PLANNING COMMISSION MEETING

SUBJECT: Serenity at Seelye Brook Preliminary Plat & Lot Width Variance

**ENGINEERING REVIEW
for City of St. Francis
by
Hakanson Anderson**

SUBJECT: AutoZone Comprehensive Plan Amendment, Rezoning, and Site Plan

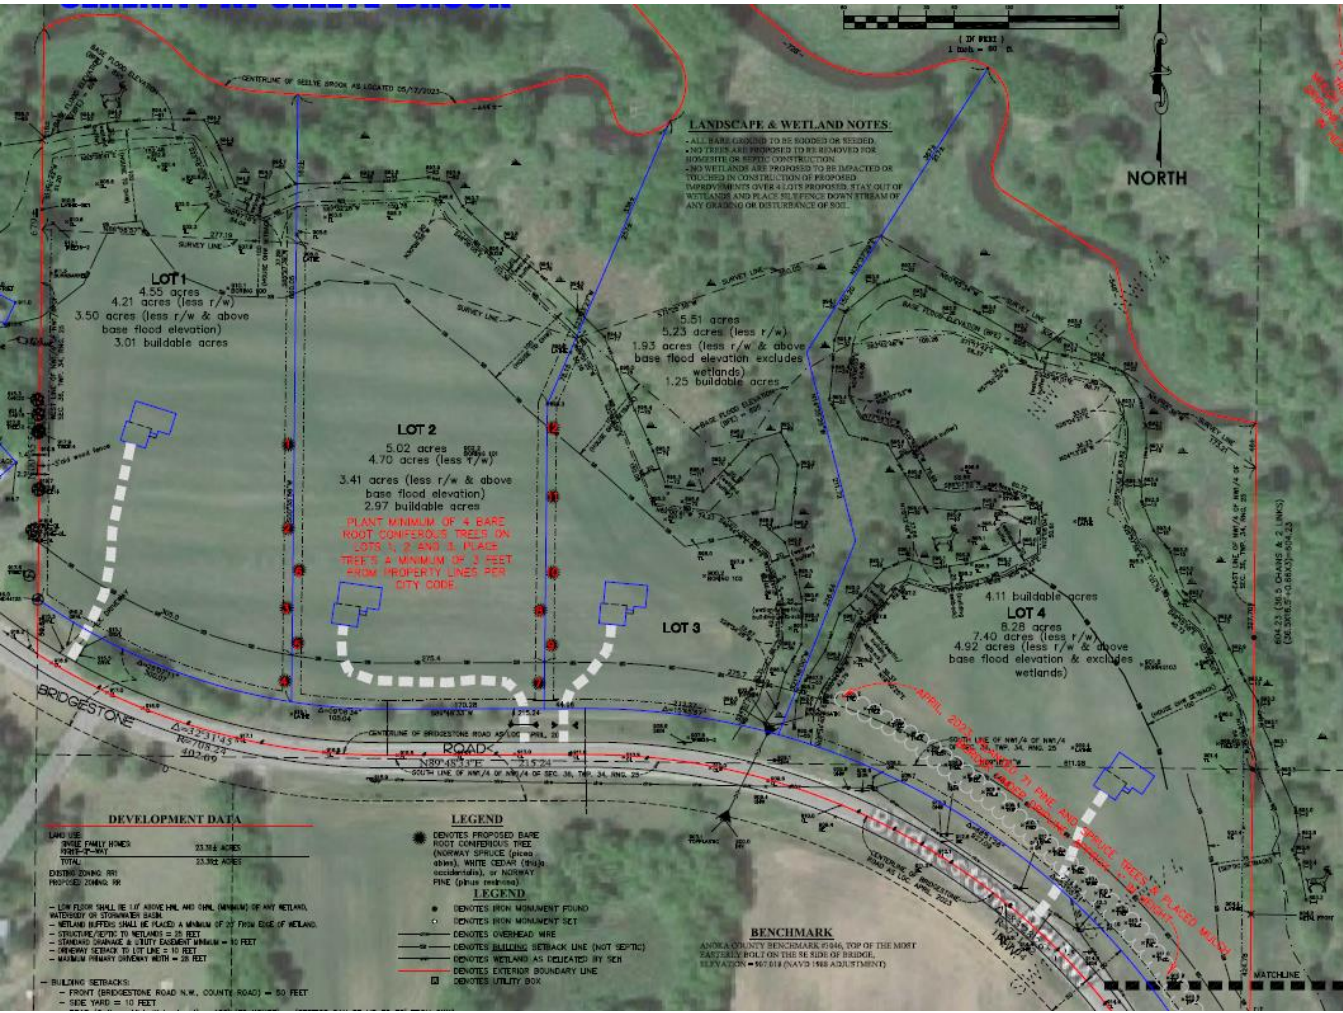
Lots 2 and 3 do not meet the minimum lot width requirement of 300 feet. Therefore, the applicant has requested a lot width variance for these lots. The applicant has shared that the lot lines were drawn to follow the natural features of the site, particularly the wetland area that runs from Seelye Brook to Bridgestone Rd NW between Lots 3 and 4. This wetland provides a logical division between lots. It separates the frontage of the site into two halves – west of the wetland is 856.1 feet and east of the wetland is 648.6 feet. The applicant is proposing to draw the lot line between Lots 3 and 4 through the wet area in order to keep the upland on each lot congregated together for ease of maintenance instead of separated by a wetland. While there

is enough overall frontage on this site for 5 lots, the location of the wetland leads to a reduction in lot width for Lots 2 and 3.

1. Applicant shall address all comments in the City Engineer's memo dated 8/8/2023.
2. Applicant shall comply with all comments from Anoka County as stated in the memo dated August 2, 2023.
3. One deciduous tree shall be planted in the front yard of each lot at the time of building permit.

4. Approval is subject to the concurrent approval of the lot width variance for Lots 2 and 3 in the Serenity at Seelye Brook development.
5. Park dedication requirements shall be resolved at the time of final plat.
6. The applicant is responsible for all fees related to the review of this application.
7. Other conditions identified during the review process by Staff, the Planning Commission, or the City Council.

GRADING AND DRAINAGE PLAN

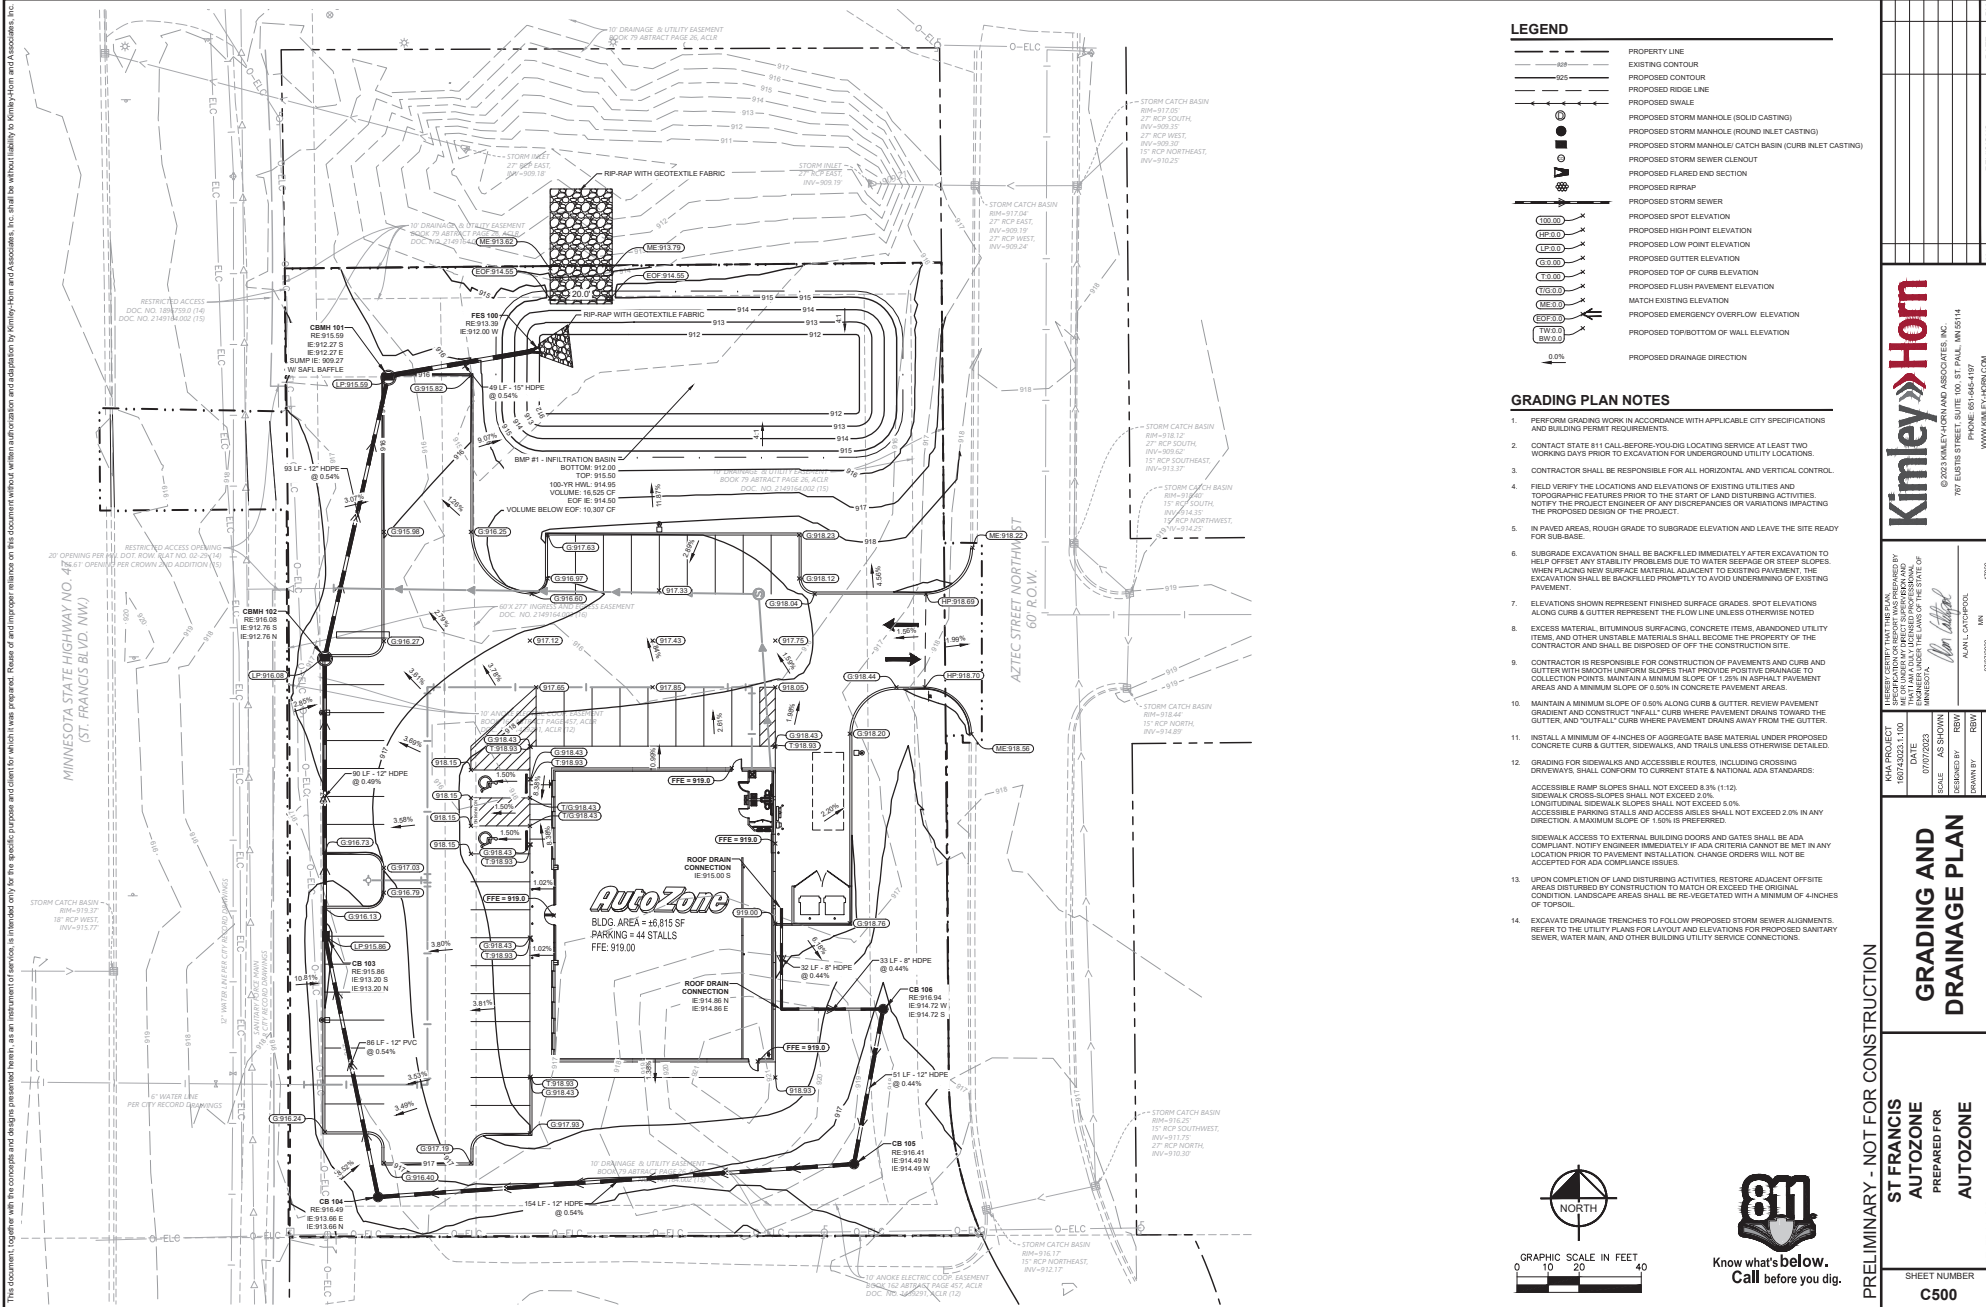
1. Please provide a storm sewer stub beginning at CB 104 and terminating ten feet to the south to allow for the off-site drainage to be conveyed via storm sewer at a future date.
2. Please provide drainage and utility easement over the storm sewer from the stub south of CB 104, to FES 100 and including the stormwater basin.
3. Please provide a detail for the proposed infiltration basin. It appears (from the soil borings) that the bottom of the basin may be near a clay layer in the soil. Please evaluate and consider infiltration mix soil at the bottom of the infiltration basin, if necessary.
4. Please specify an appropriate seed mix for the infiltration basin, including the slopes. Alternatively, if the seed mix / planting schedule has already been prepared please direct us to the location in the plans.

LANDSCAPE PLAN

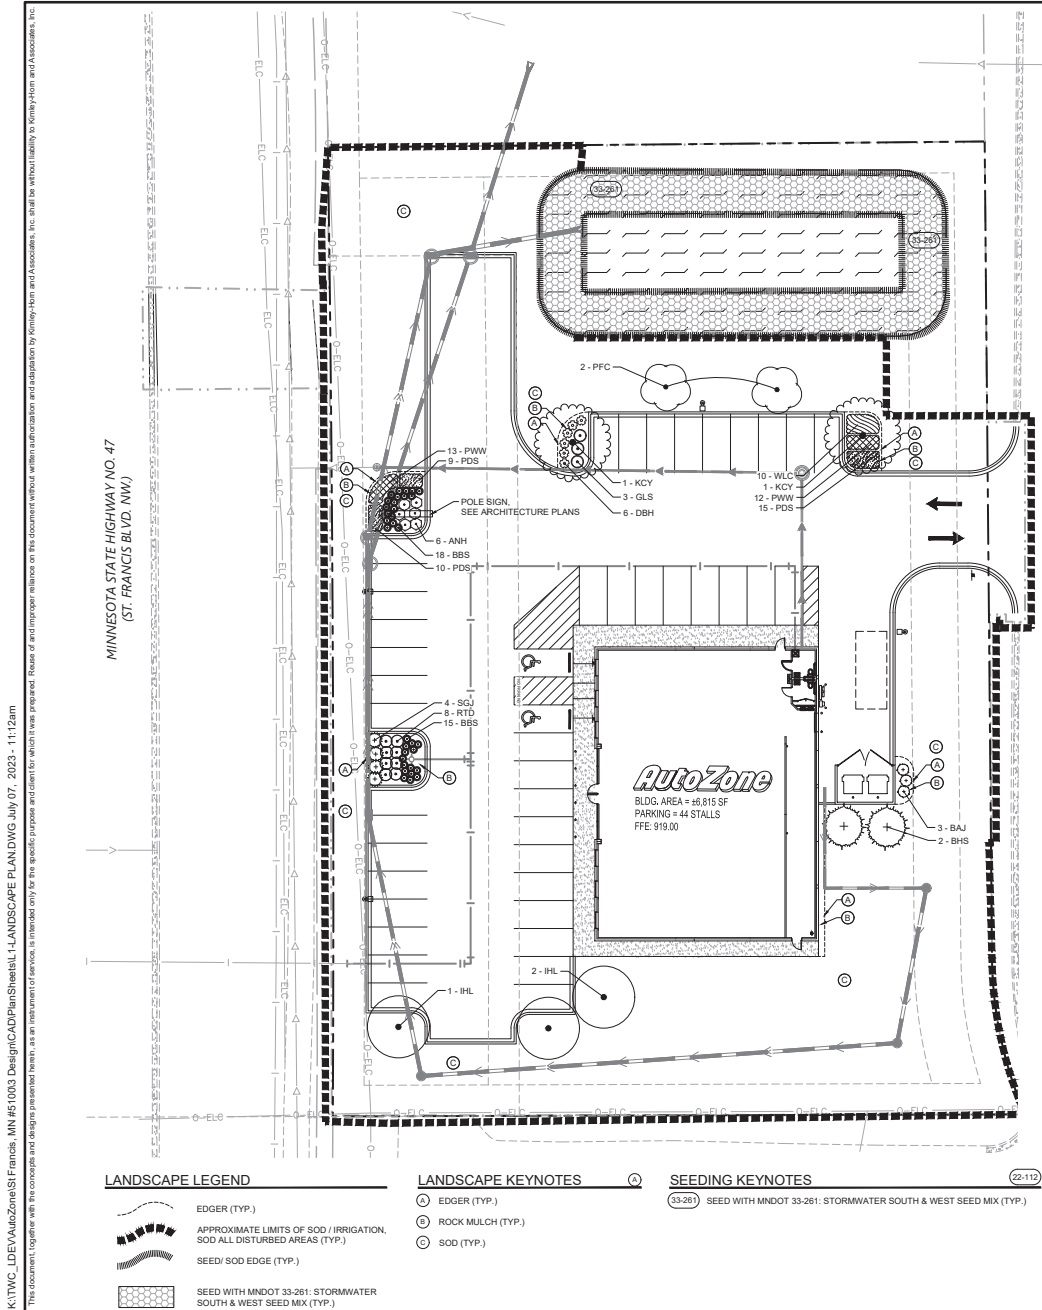
A landscaping plan for the site was submitted and reviewed by Staff. The applicant is proposing to plant 9 trees throughout the site, which meets the requirement for vegetation on the property. While the number of trees to be planted meets Code, the types of trees proposed do not meet diversity requirements. The City requires that no more than 25% of the caliper inches planted come from the same genus. Currently, Imperial Honeylocust trees make up over 26% of the proposed caliper inches required. Staff recommends that the applicant revise the tree types to be planted to meet diversity requirements.

1. The City recently updated its Private Development Standards. Please utilize the updated Standard Plates, which are to be provided under separate cover.
2. Please review the storm sewer lines depicted on the Landscape Plan. The current Landscape Plan depicts two storm sewer alignments, one of which we assume is outdated.

6. The eastern exterior façade of the building shall be revised to meet the requirements for façade articulation and windows as specified in Code Section 10-71-08C.
7. Tree plantings shall not consist of more than 25% caliper inches of one genus.
8. The applicant should provide details of the rooftop mechanical equipment and where on the roof it will be located in order to ensure it is screened from view of the street.
9. All signage shall meet Code requirements and shall be reviewed through the sign permit process.
10. Other conditions identified during the review process by Staff, the Planning Commission, or the City Council.

Color Elevation
 AutoZone Store #5100
 ST. Francis, MN

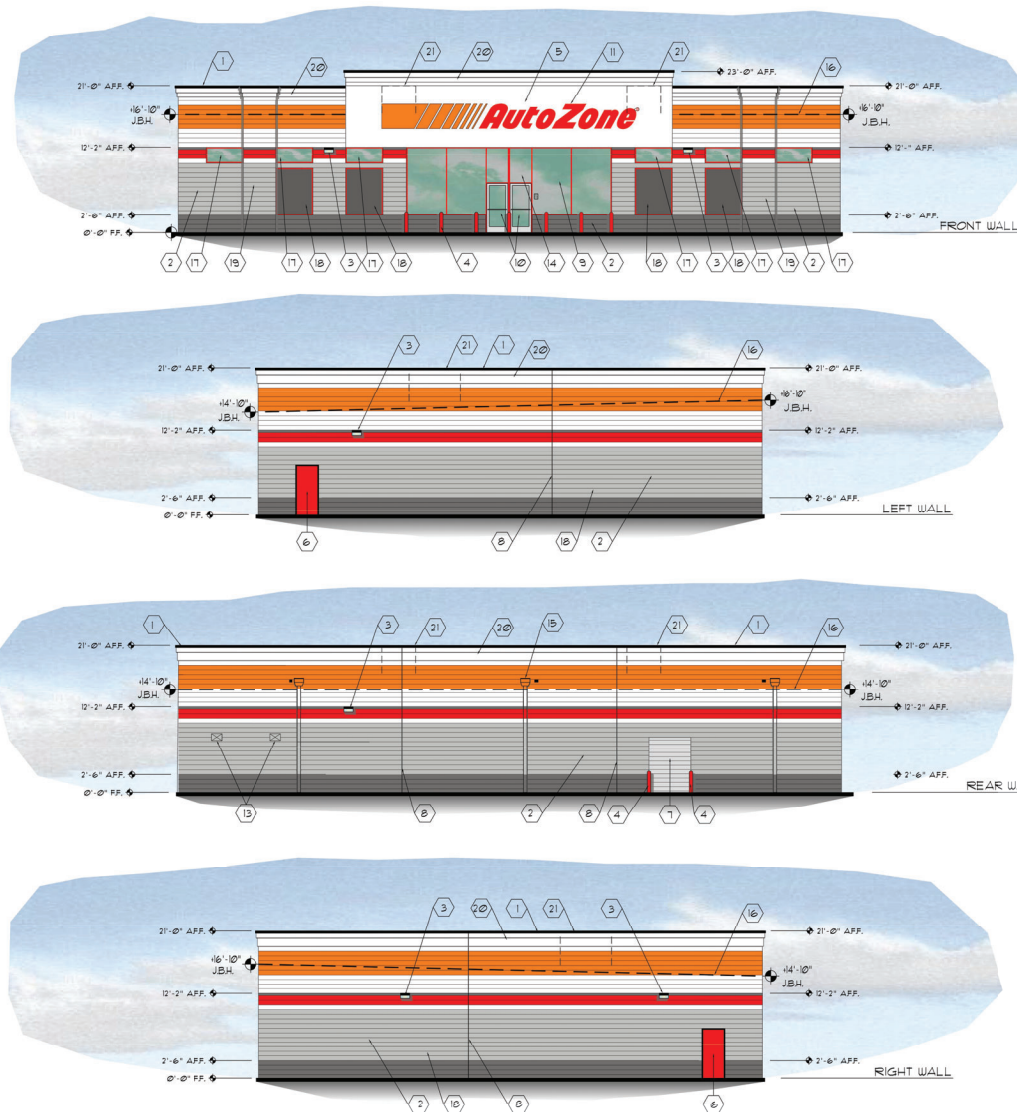
The subject site has frontage on both Hwy 47 and Aztec St NW. The west side of the building facing Hwy 47 is proposed as the “front,” and includes the main entrance, windows, and façade articulation. The east side of the building facing Aztec St NW does not currently meet the standards listed above. The applicant must revise the exterior façade on the east side of the building to meet those requirements.
